Access Compliance Report Public Rights-of-Way (Curb Ramps)

Intersection ID: 23887	Main Street: FOXGLOVE_DR	Cross Street: REA_RD	Location: SW
ADA ID: 2AB69B59F7B5	Ramp Type: PerpDiag	Initial Pass/Fail: Pass	Overall Compliance: No Severity Score: 10

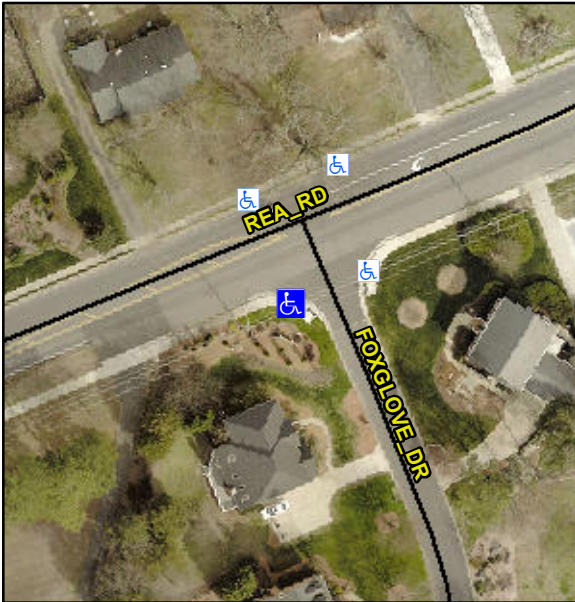
Not Found, R304.2.1, R304.2.2-Perp, R304.3.2-Para, R304.5.3

Compliance	Description	Data	Compliance	Description	Data
N/A	Ramp Length (in)	71.0	Yes	Ramp Slope (%)	6.5
Yes	Ramp Width (in)	69.0	Yes	Ramp XSlope (%)	1.6
Yes	Flare Type LCurbed_NoWalkSurface		N/A	Flare Type RT	N/A
Yes	Flare Slope LT (%)	N/A	Yes	Flare Slope RT (%)	9.6
N/A	Flare Traversable LT?	No	N/A	Flare Traversable RT?	Yes
No	Landing Length (in)	N/A	Yes	DWS Provided?	Yes
No	Landing Width (in)	N/A	Yes	DWS Contrast?	Yes
No	Landing Slope (%)	N/A	Yes	DWS Length (in)	24.0
No	Landing X Slope (%)	N/A	Yes	DWS Full Width?	Yes
N/A	Landing Curb? (Y/N)	Yes	Yes	DWS Offset (in)	2.0
N/A	Shared Landing?	No			
Yes	Gutter Ponding?	No	Yes	Gutter Slope (%)	1.5
Yes	Gutter Lip Ht (in)	0.0	Yes	Gutter X Slope (%)	1.3
N/A	Painted X Walk1?	No	N/A	Painted X Walk2?	No
	X Walk 1 Direction	To E		X Walk 2 Direction	To N
N/A	X Walk 1 Width (in)	N/A	N/A	X Walk 2 Width (in)	N/A
	X Walk 1 Slope (%)	1.5		X Walk 2 Slope (%)	2.8
	X Walk 1 X Slope (%)	0.9		X Walk 2 X Slope (%)	1.8

N/A	Ramp inside XWalk1?	N/A	N/A	Ramp inside XWalk2?	N/A
	Road Slope (%)	1.7	N/A	Clear Space?	Yes
	Road X Slope (%)	1.7	N/A	Clear Space to XWalk (in)	N/A
Yes	Any Obstructions?	No	Yes	Storm Grate/Utility Hazard?	No
	Obstruction Type			Storm Grate/Utility Type	
			N/A		N/A
			Yes	Surface Condition? (G/P)	Good

Remove & Replace Curb Ramp With Two New Directional Ramps or Equivalent.
